STAFF REPORT

Transportation Plan Amendments

December 9, 2025 Town Council Meeting

Figure 1. Proposed amendments to the Thoroughfare and Collector Street Plan Map

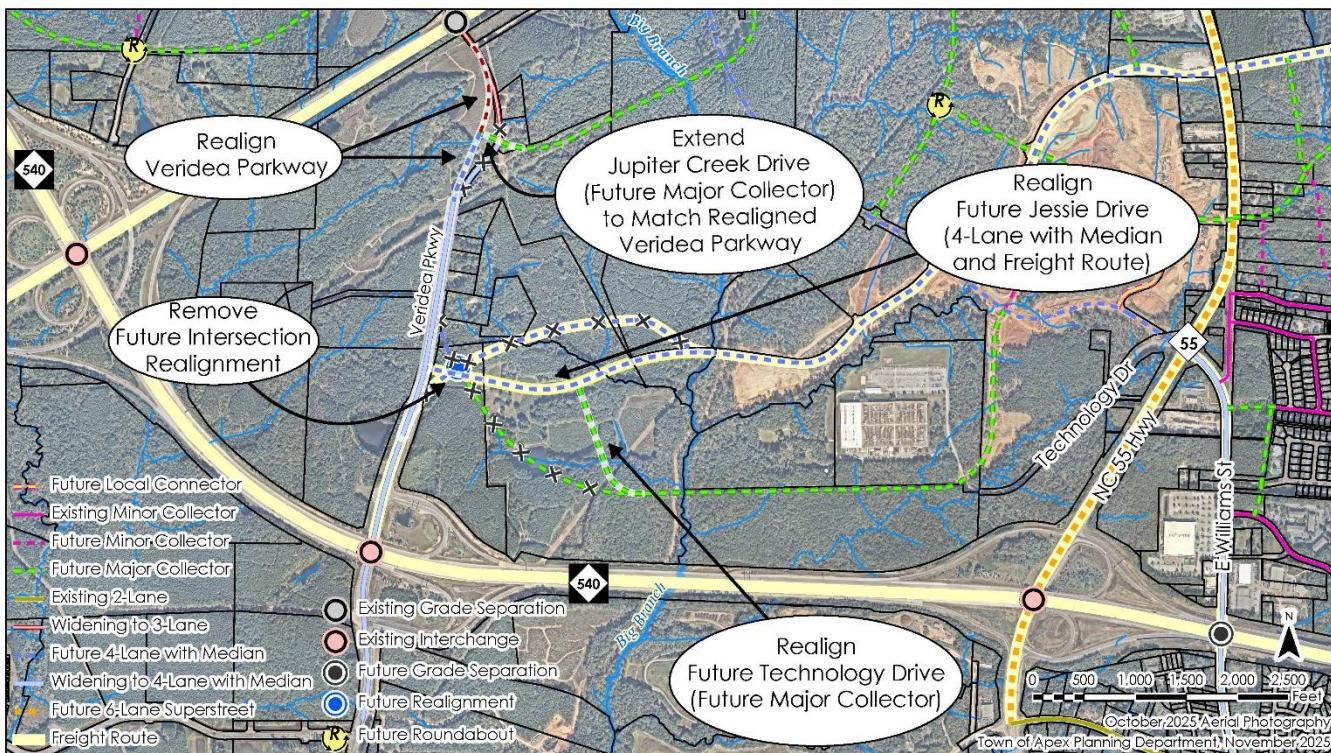
The primary roadway amendment is to remove the planned intersection realignment of existing Veridea Parkway and future Jessie Drive. This amendment is requested because an updated Traffic Impact Analysis that includes the North Carolina Children's Hospital shows that there would be substantial left-turn movements from Jessie Drive onto Veridea Parkway. This left-turn movement is projected to be over 1,300 vehicles during the morning peak hour and over 500 vehicles in the afternoon peak hour. The turning movements would overwhelm this intersection and cause significant queueing on Veridea Parkway towards NC 540 based on the current plan to make Jessie Drive the through-movement between NC 55 and NC 540. These volumes would likely require a third left-turn lane and an additional receiving lane on Veridea Parkway north of the intersection. Instead, the north-south movement of Veridea Parkway should remain the through-movement, with a turn needed to get onto Jessie Drive. With this configuration, the turning volumes to and from Jessie Drive would be approximately 300 vehicles or less during each peak hour after construction of the NC Children's Hospital, a more manageable volume.

Due to the proposed removal of the intersection realignment at existing Veridea Parkway and future Jessie Drive; adjustments to the planned alignment of future Technology Drive extension are also needed. The proposed amendment shifts the alignment of future Technology Drive extension to the east, to provide sufficient spacing

for a full-movement intersection along Jessie Drive. Further consideration of whether this major collector could intersect Jessie Drive even further east to avoid stream impacts is expected as part of Peak Plan 2055, but is not proposed at this time, given it would involve property outside of the rezoning case. Other amendments to the Thoroughfare and Collector Street Plan Map include minor adjustments to the alignment of Veridea Parkway and proposed Jupiter Creek Drive to reduce the curvature of Veridea Parkway in this section and improve sight distance at the intersection with Jupiter Creek Drive.

Figure 2. Proposed amendments to the Bicycle and Pedestrian System Plan Map

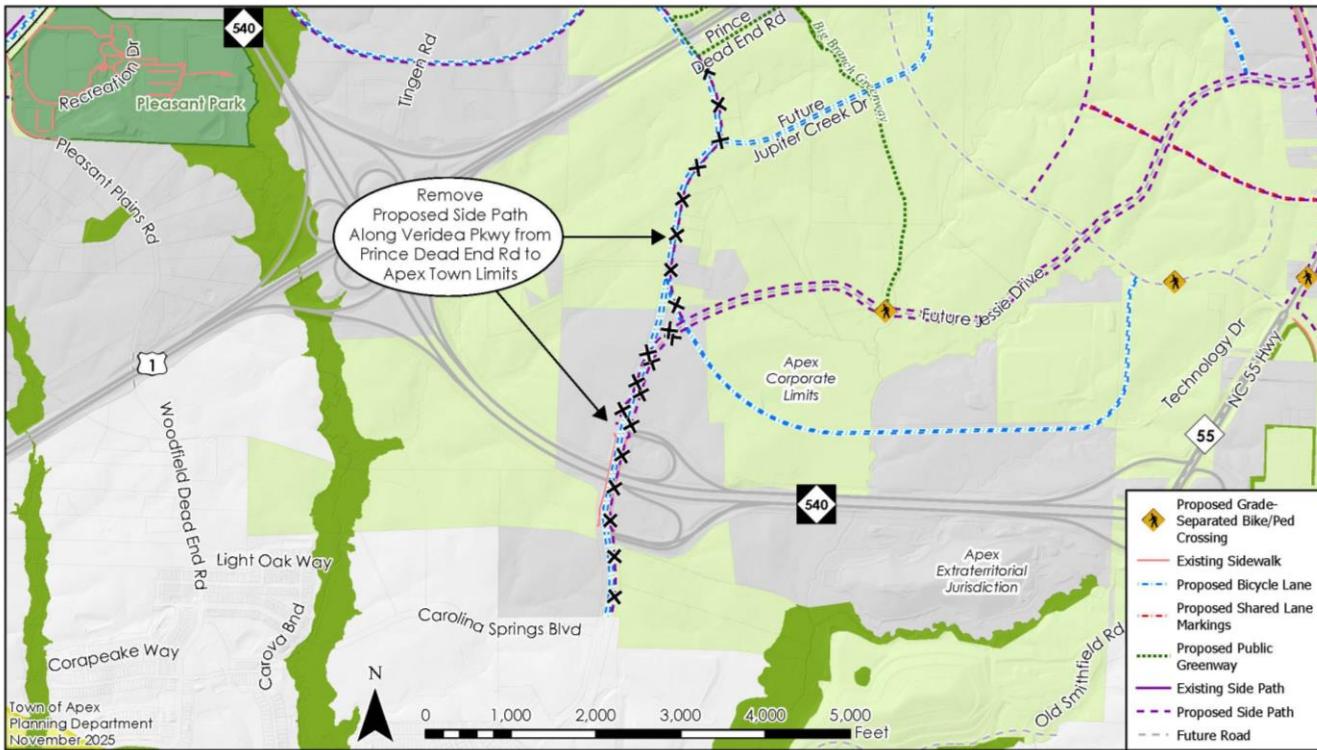
The proposed amendment to the Bicycle and Pedestrian System Plan Map is to remove the future side path along Veridea Parkway from approximately Carolina Springs Boulevard to Prince Dead End Road. This change is associated with feedback from the North Carolina Department of Transportation (NCDOT). NCDOT has indicated that they are not supportive of on-street bicycle lanes if a separated facility, like a side path, is provided. NCDOT also prefers vertically-separated facilities, especially along four-lane thoroughfares and higher-capacity, higher-speed roadways. Planning staff believe that a side path provides a different function than bicycle lanes given they mingle pedestrian and bicycle traffic and do not provide the same visibility for fast-moving bicycles along a roadway. During the public engagement process for Bike Apex, staff heard strong interest for bicycle facilities that would be separated from pedestrian traffic along specific roadways commonly used by road cyclists, including Veridea Parkway and Tingen Road. Given these considerations; the applicant, NCDOT, and Town staff agreed with a proposed amendment to remove the side path from the Bicycle and Pedestrian System Plan Map, but to construct the bicycle lanes as separated bicycle lanes, located behind the roadway curb. These lanes would be separated from both vehicular and pedestrian traffic. This configuration will also address potential conflicts between a stopped bus and bicycle lanes along this future transit route. Note, the existing bridges at US 1 and NC 540 will continue to be "pinch points" for bicycle and pedestrian facilities along Veridea Parkway until substantial infrastructure improvements can be made. A diagram representing the typical section for the three-lane section of Veridea Parkway between Jupiter Creek Drive and Prince Dead End Road is shown in Figure 3. A representative typical section for the four-lane section of Veridea Parkway is shown as Figure 4.
